**UNITED STATES  
NUCLEAR REGULATORY COMMISSION**  
WASHINGTON, D.C. 20555-0001

SUBJECT: UPDATED DRAFT ASSESSMENT OF FUKUSHIMA  
RECOMMENDATIONS RELATED TO: 1) EVALUATION OF NATURAL  
HAZARDS OTHER THAN SEISMIC AND FLOODING, 2) ONGOING  
ASSESSMENT OF NATURAL HAZARDS, AND 3) REAL-TIME  
RADIATION MONITORING

## Evaluation of Natural Hazards other than Seismic and Flooding

Figure 2.1.4-1 Comparison of Current Design Basis Wind Speeds vs Updated Tornado and Hurricane Wind Speeds\*

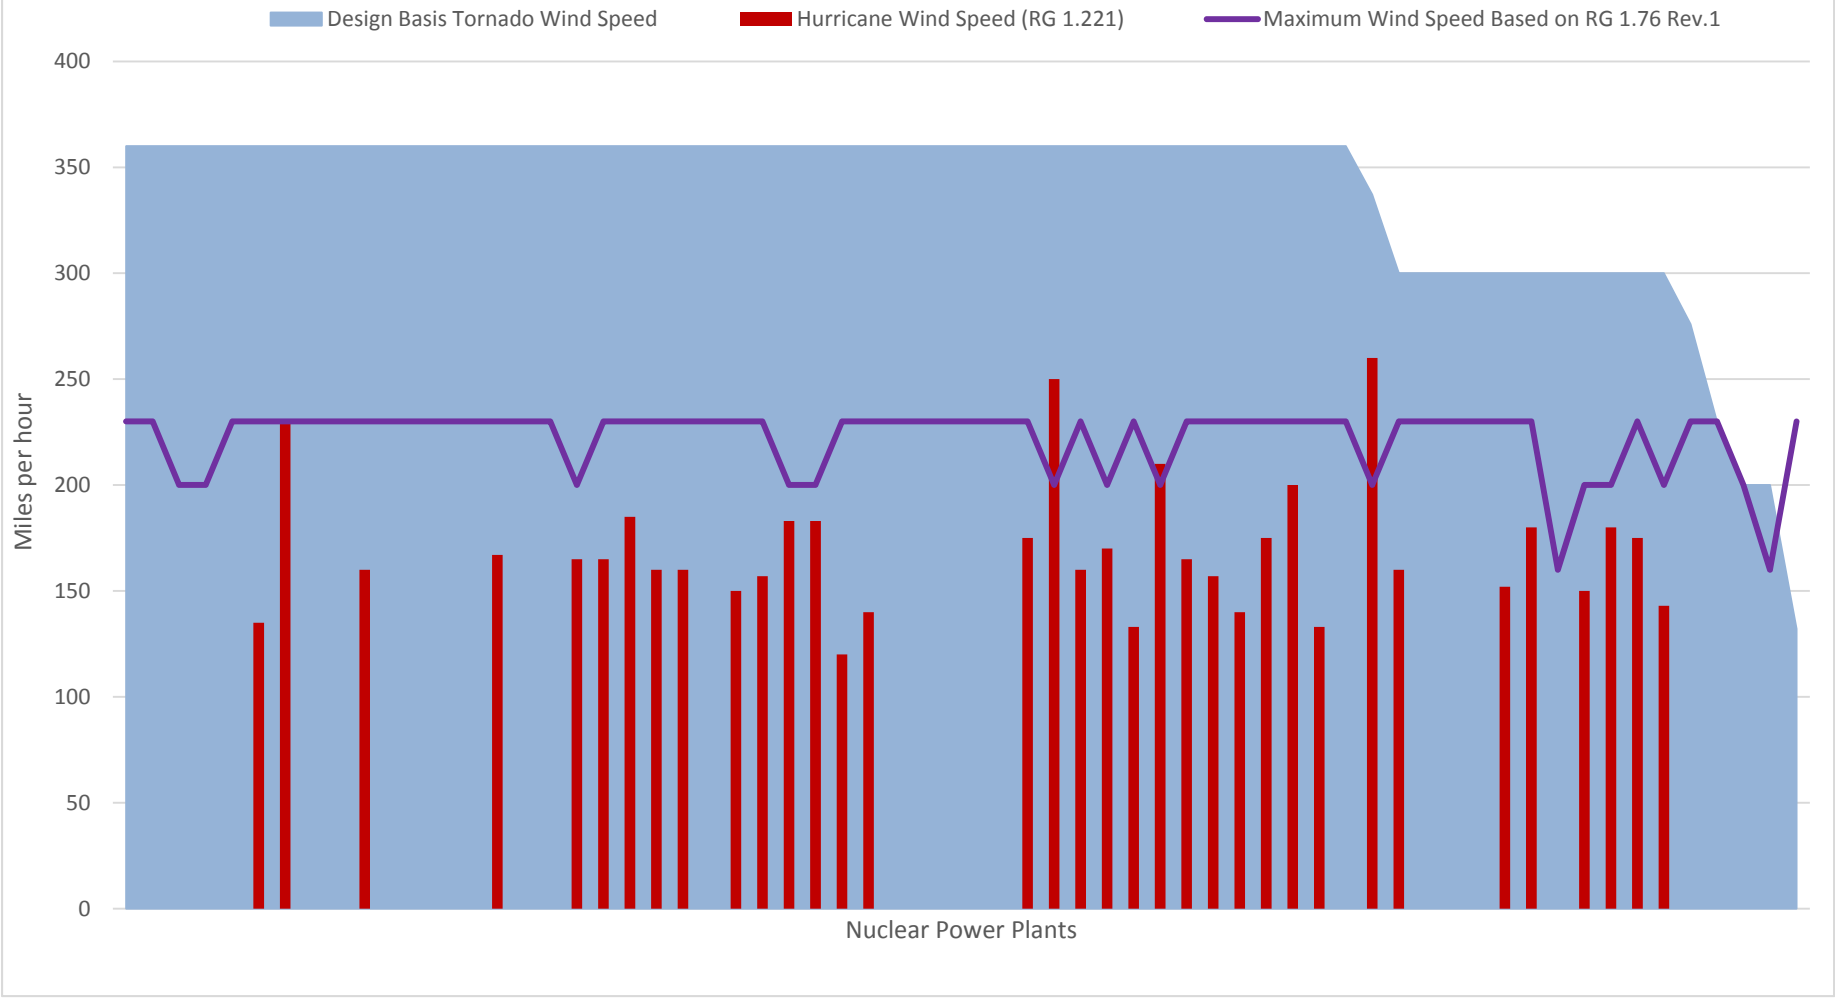
Figure 2.1.4-1, "Comparison of Current Design Basis Tornado Wind Speeds vs Updated Tornado and Hurricane Wind Speed," ~~located at the end of this enclosure,~~ plots the data that the NRC staff collected. As noted with the blue shade plot in Figure 2.1.4-1, the majority of nuclear power plants were designed for a tornado wind speed of 360 miles per hour.

Figure 2.1.4-1 shows that for the majority of the sites, the RG 1.76, Revision 1, tornado wind speeds (shown as the purple line in the plot) are less than those assumed in the design of the plant. Regarding hurricanes, Figure 2.1.4-1 shows that not every plant has an associated hurricane wind speed (shown by the red bars in the plot). This is consistent with the guidance found in RG 1.221 that does not provide hurricane wind speeds for plants that are far inland because of the assumption that the tornado wind speed will bound a hurricane wind speed for these sites. Regardless, Figure 2.1.4-1 shows that for the majority of sites, the hurricane wind speed is bounded by the design-basis tornado wind speed provided in the UFSAR.

The staff notes that for one site (Ginna), on the far right of the horizontal axis in Figure 2.1.4-1-1, the design-basis tornado wind speed is less than that found in RG 1.76, Revision 1 (for tornados), or RG 1.221 (for hurricanes). One of the ~~site's~~ design basis tornado wind speed is not the same for all safety-related SSCs (Oyster Creek). In addition, not every ~~site~~ plant was licensed with a design-basis tornado wind speed (Nine Mile Point 1 and Indian Point 2).

# Figure 2.2-1 Snow Loads

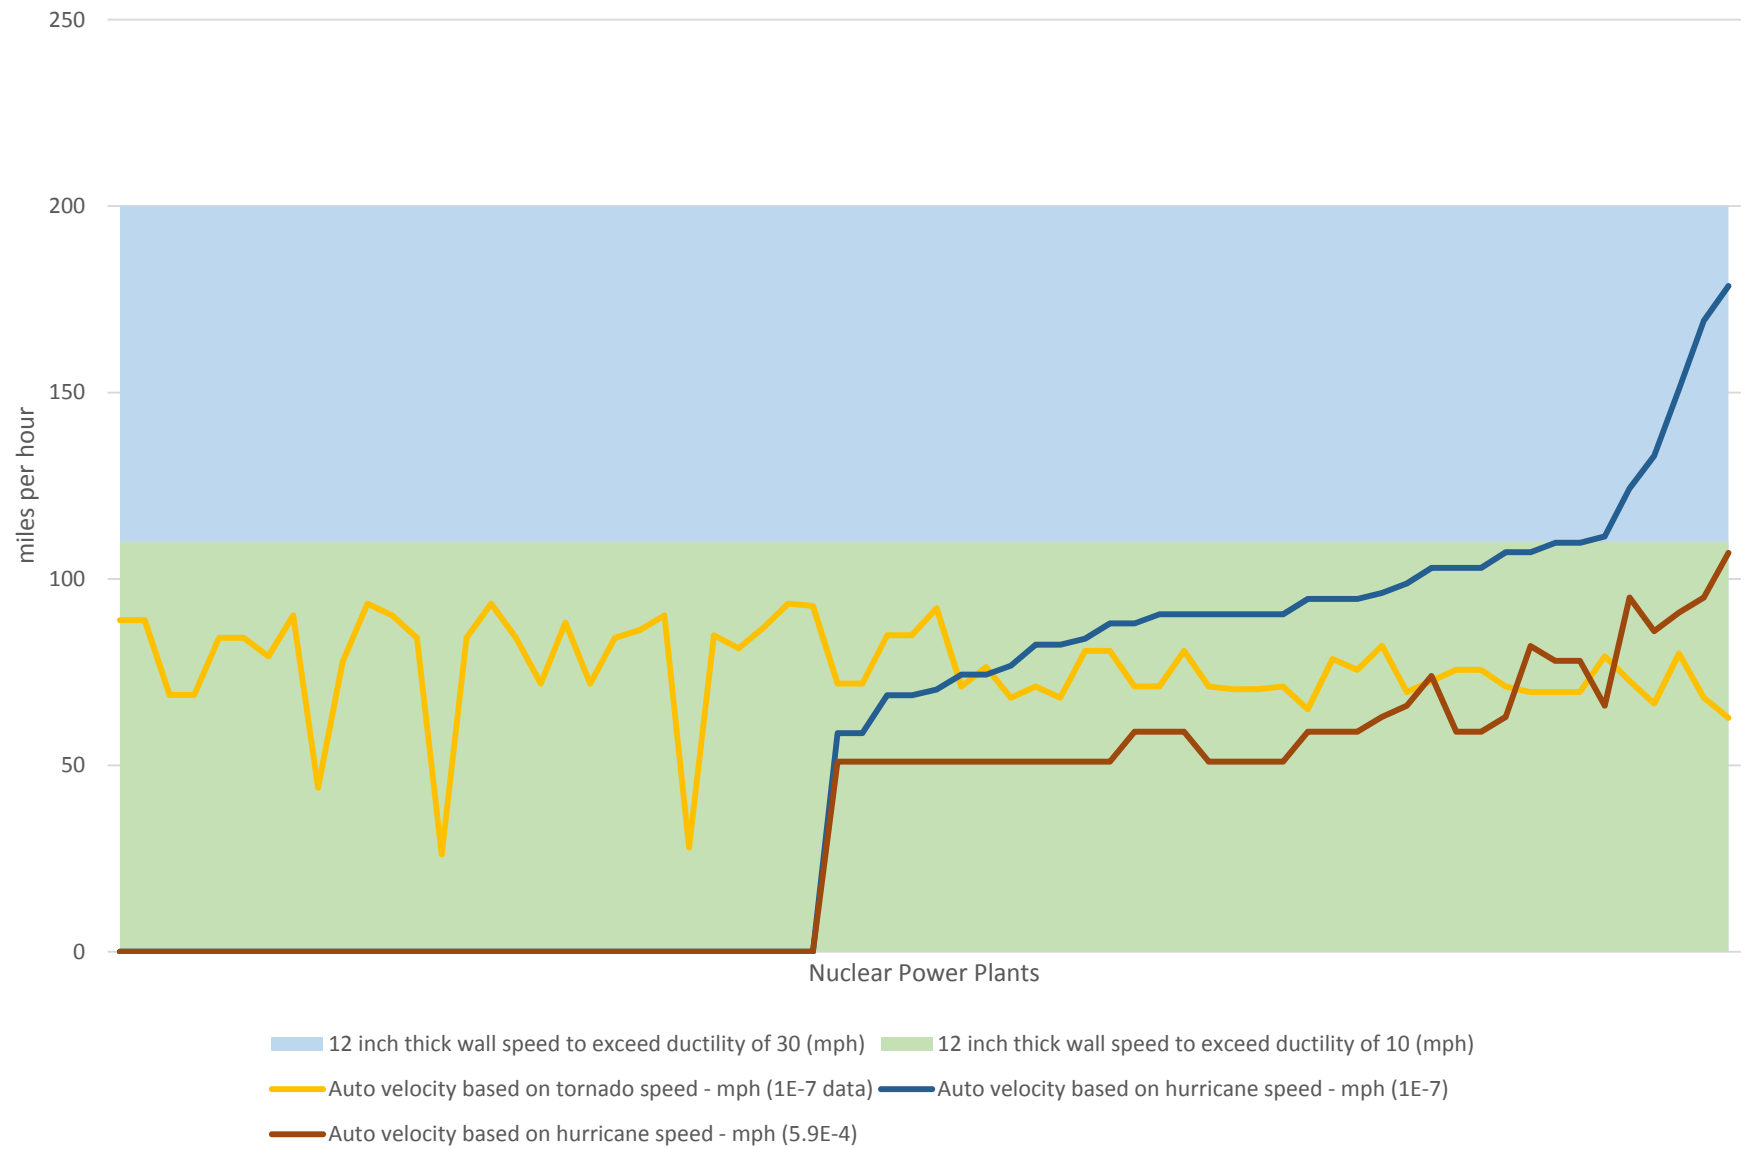
The NRC staff calculated the 100-year snow load and extreme snow load for the current operating fleet based on guidance provided in DC/COL-ISG-7. Figure 2.2-1 provides a plot of the staff-calculated 100-year snow load and extreme snow loads for current operating nuclear power plants (ten sites whose 100-year snow load is zero based on ASCE-7 information are not plotted on this figure). The staff performed additional structural assessments for these sites by developing equivalent roof loading for a representative reinforced concrete roof. The staff's evaluation included developing the dead load for this representative roof. Figure 2.2-1 plots double the dead load of a representative concrete roof that equates to a 225 pounds per square foot roof loading. Doubling the representative roof dead load is within the structural design margin of the representative roof.

Figure 1: Key elements of proposed R2.2 Program

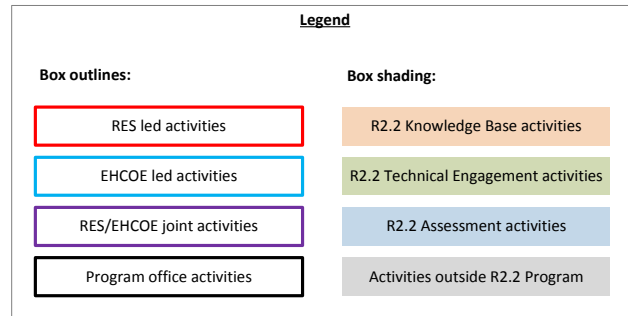
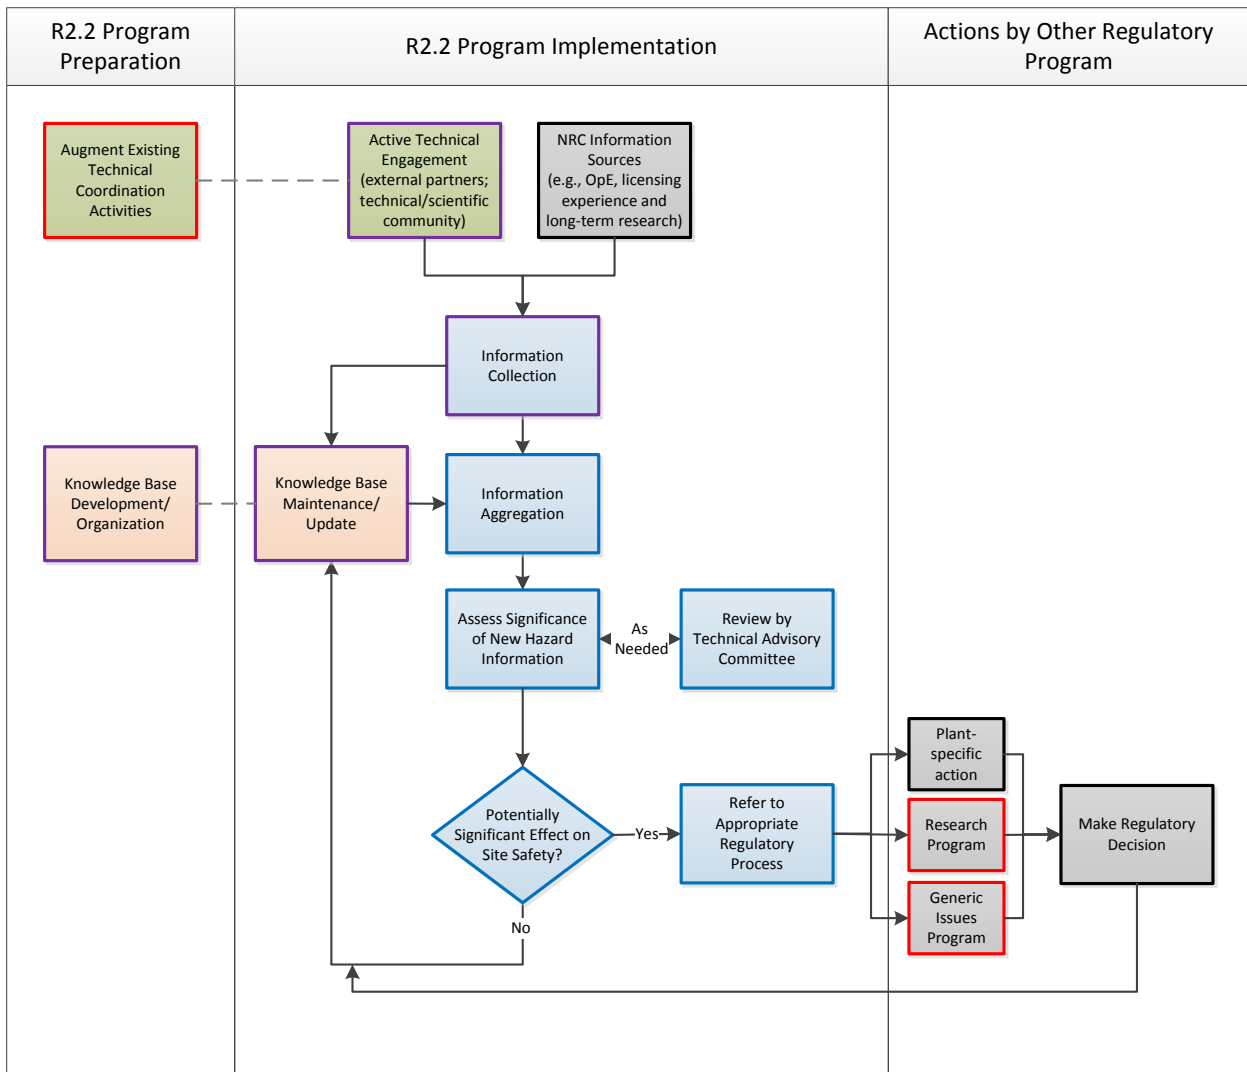
The staff's proposed framework for hazard reevaluation is shown in Figure 1 and consists of three primary components:

~~Details~~Section 4 of this enclosure provides greater detail on the above components ~~are provided in Section 4.~~
